File 1991-0070

Name: North Avenue Marketplace - Final / Rezone

SUBJECT: Review of revised plans dated November 18, 1991

REVIEW SHEET SUMMARY

LANDSCAPE PLAN

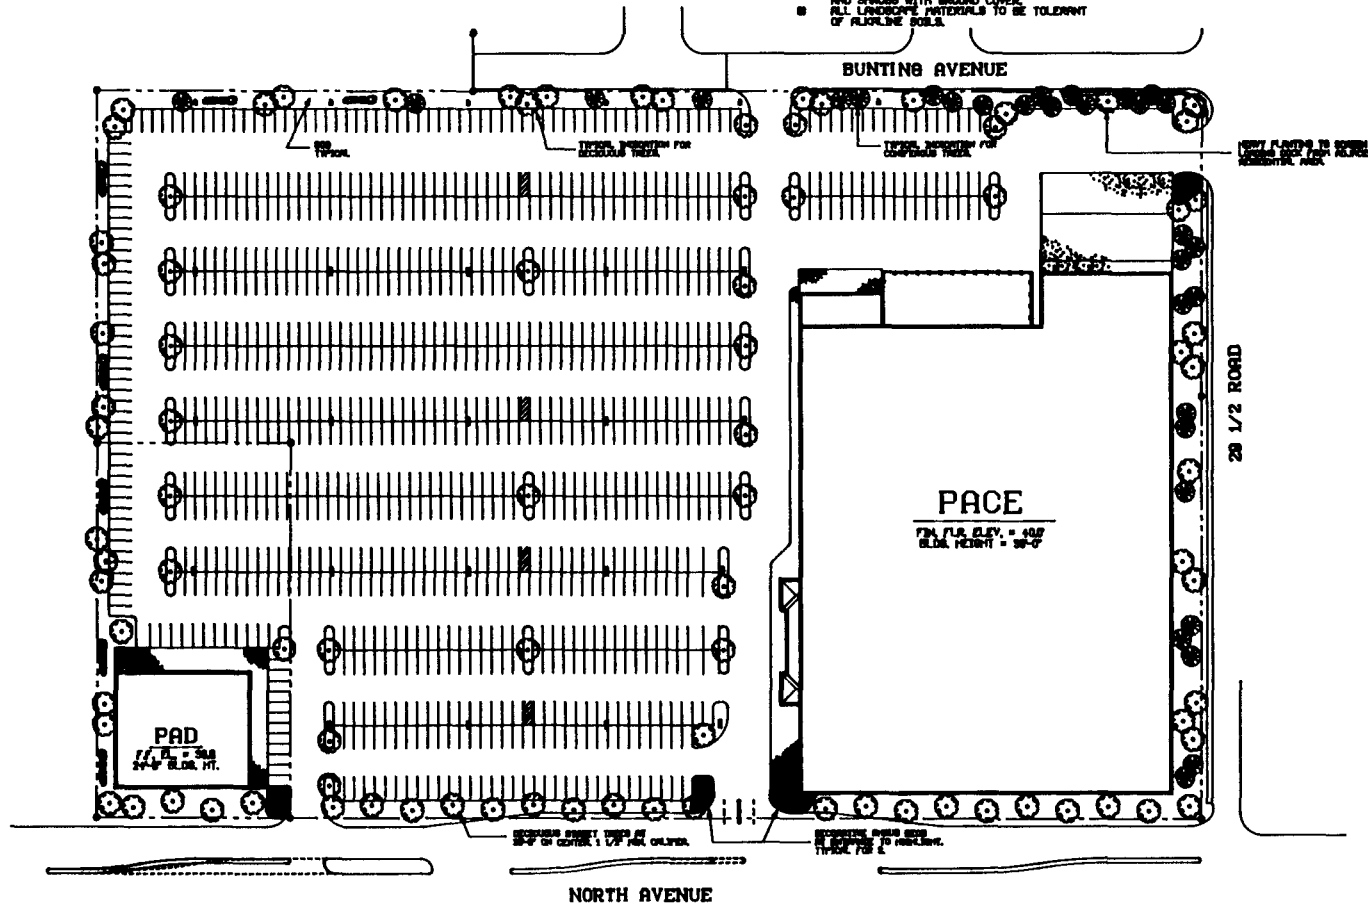
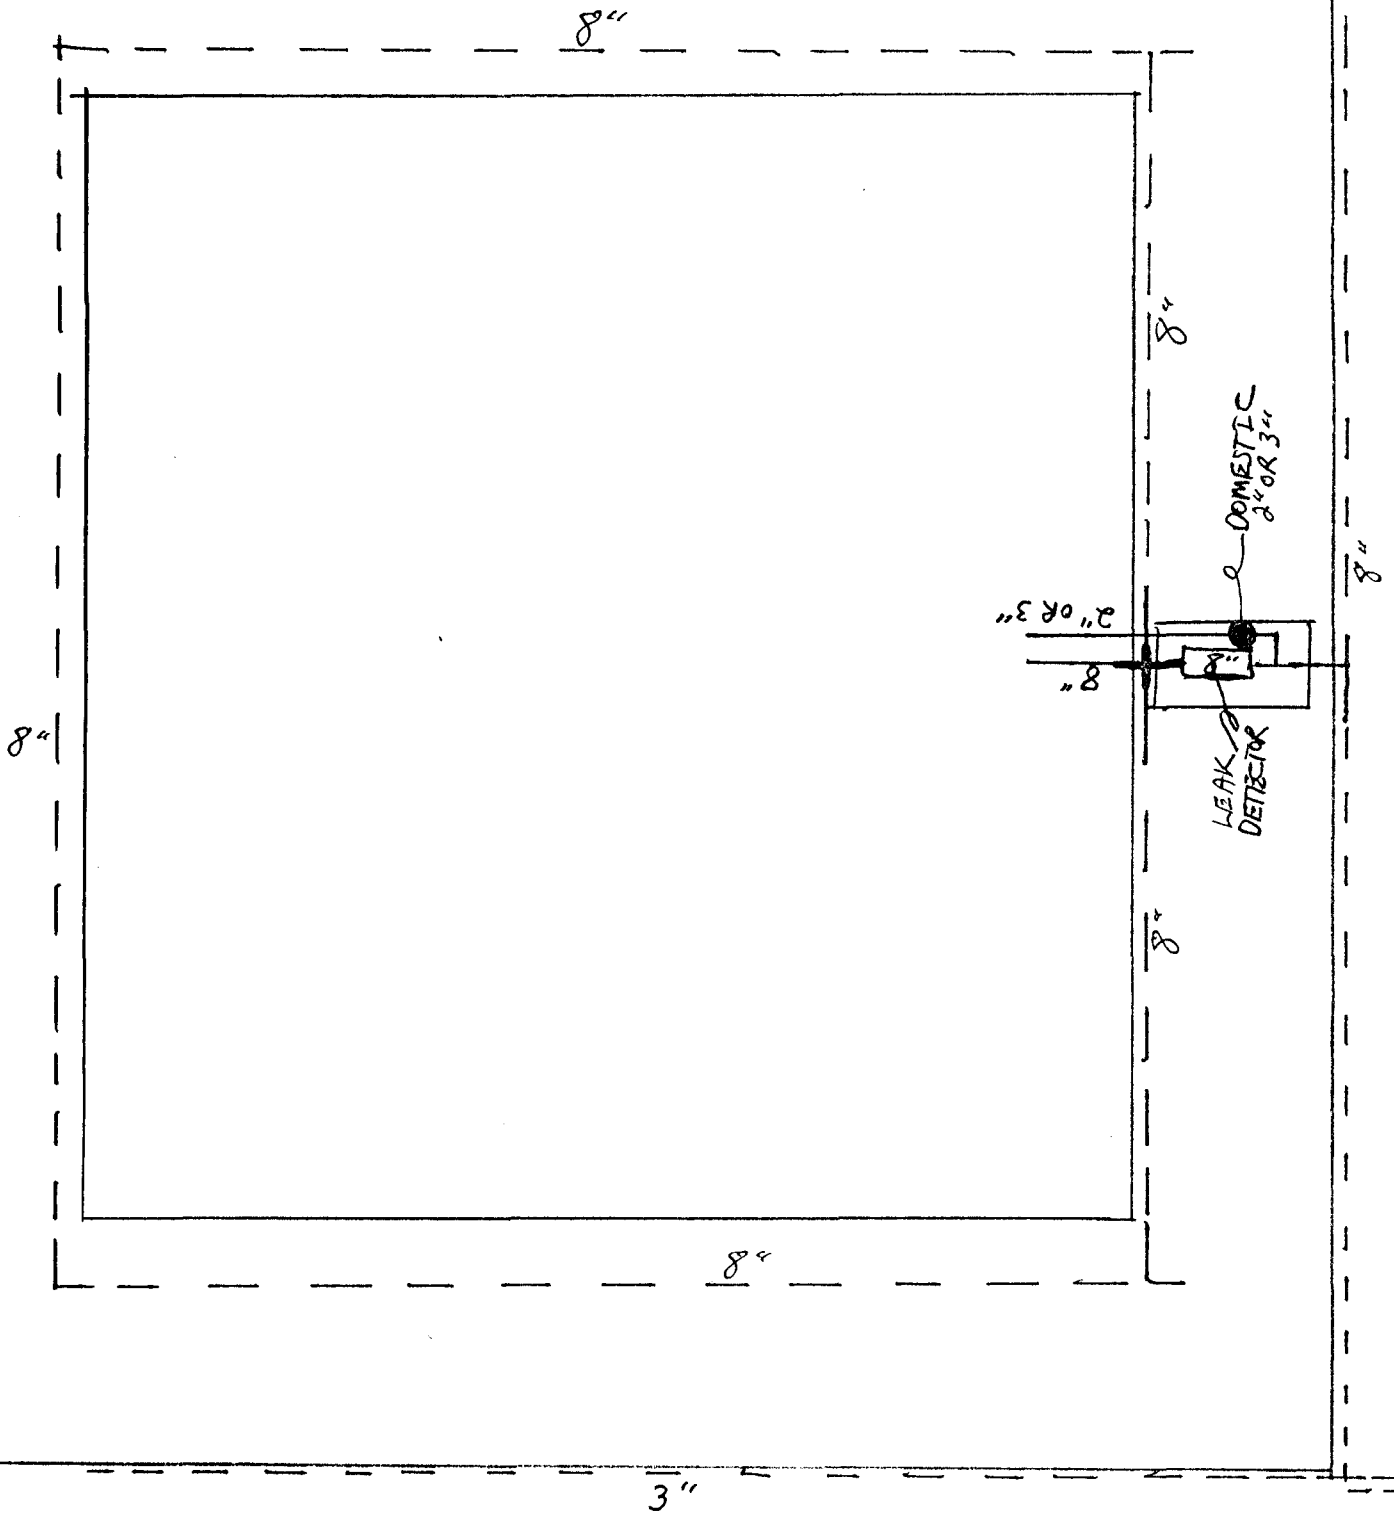
LANDSCAPING PLAN: Unobstructed sight distance from all curb cuts shall be provided in accordance with Section 1.6.4 Sight Distance, in the City of Grand Junction Street Standards.
